ACCESSION NBR: 8006170323 DOC. DATE: 80/06/10 NOTARIZED: NO DOCKET #
 FACIL: 50-410 Nine Mile Point Nuclear Station, Unit 2, Niagara Moho 05000410
 AUTH. NAME AUTHOR AFFILIATION
 RHODE, G.K. Niagara Mohawk Power Corp.
 RECIP. NAME RECIPIENT AFFILIATION
 RUBENSTEIN, L.S. Assistant Director for Reactor Systems

SUBJECT: Forwards final responses to geologic info Requests Q361.1, .2, .13, .14 & .24 per 791001 request.

Re: Nine Mile Point Unit 2
Docket No. 50-410

Attached are the responses to geologic information Requests Q361.1, 361.2, 361.13, 361.14 and 361.24 for Nine Mile Point Unit 2. This completes our response to all requests for information contained in your October 1, 1979 letter.

SHOWING RELATION OF PRINCIPAL STRESS ORIENTATIONS TO EAST-DIPPING THRUST FAULTS

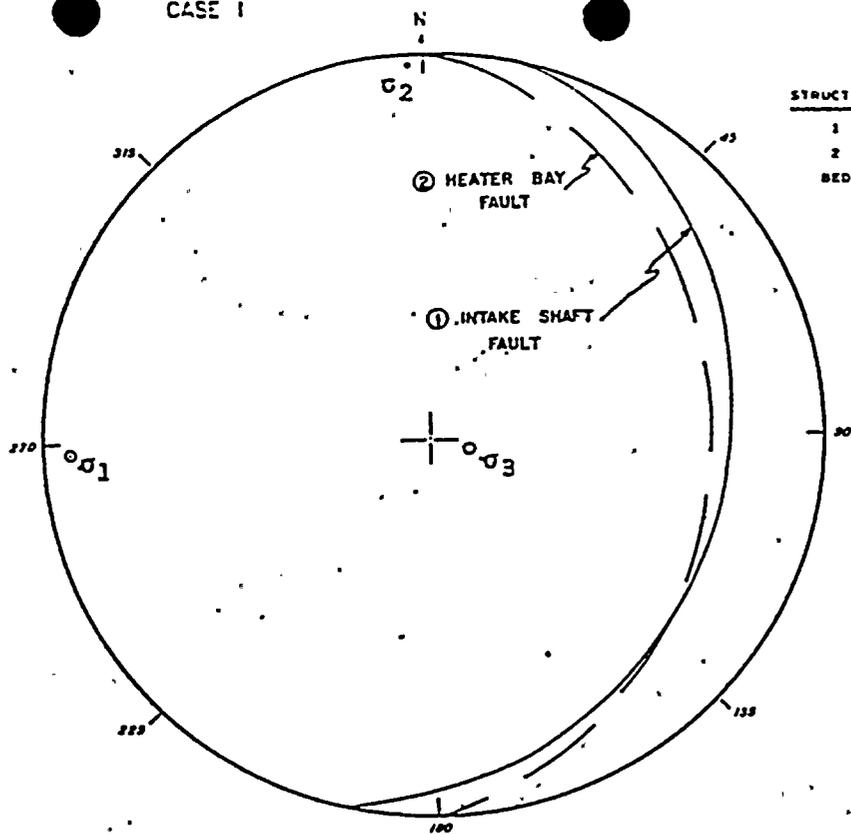
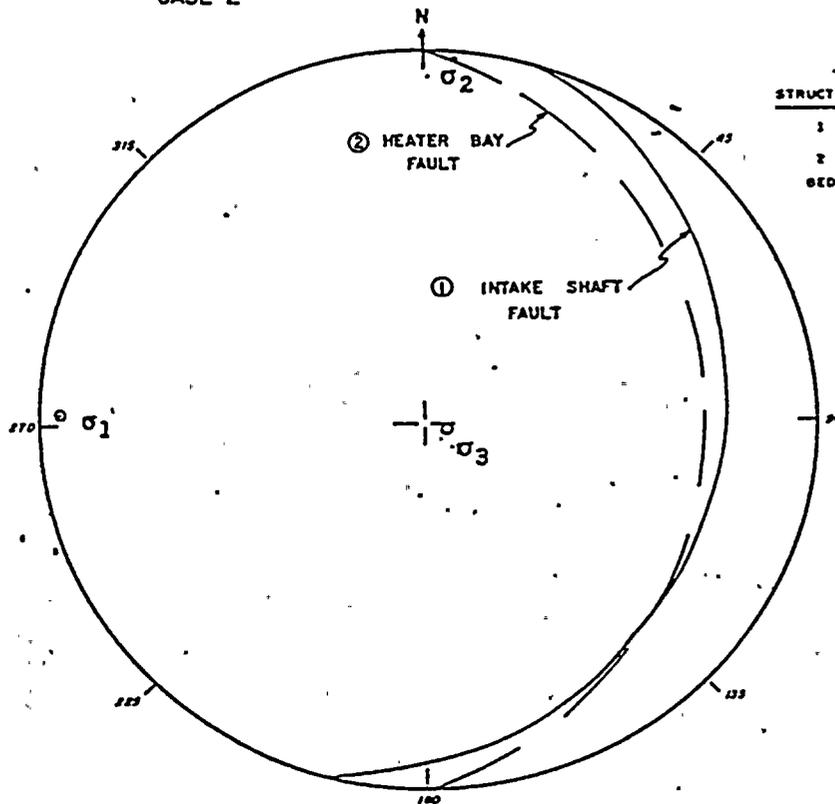
Q361.1

- d. A fourth line of evidence given is that the necessary stress orientation for causing most of the geologic structures in the main power block island are probably similar in orientation to those responsible for the development of the regional fracture pattern that is believed to have occurred during the Late Paleozoic. However, the current stress regime at this location, based on in situ measurements made during this investigation, are relatively high and also commensurate with the orientations, attitudes and sense of last movements along the thrust faults in the heater bay, radwaste building and the intake shaft. Expand your discussion of the origin of these features including all the data that indicate age and causes of the deformation. Perform an analysis to assess whether or not current existing stresses in the vicinity of Unit 2 will produce adjustment-type movements on the low angle thrust faults. Among the factors to be considered in this analysis are: orientations and magnitudes of stresses, pore pressures, swelling characteristics of bedrock, and effective stresses normal to the fault plane.

The stress tensor determined from strain-relief measurements in the Intake Shaft (NMPC, Vol. III, 1978) is commensurate with the orientation and sense of the slip vector indicated by the displacements identified along the Radwaste Fault and the east-dipping shaft fault. The stability of these faults has been evaluated as shown on Figure 361.1-1. For two cases (Table 3-18, Vol. III, NMPC, 1978) the normal stress and shear stress on the faults and on bedding were resolved from the three principal stresses, and the results are tabulated for each case (Figure 361.1-1).

Comparison of the computed values of shear stress with the shear strength for the east-dipping inclined faults reveals they are approximately equal if friction and cohesion parameters from laboratory testing are applied to analysis of the entire fault as a hypothetical, idealized plane. The irregular geometry of the fault (ranging in dip from 0 to 50 degrees) and the asperities on the fault plane contribute to the stability of the faults.
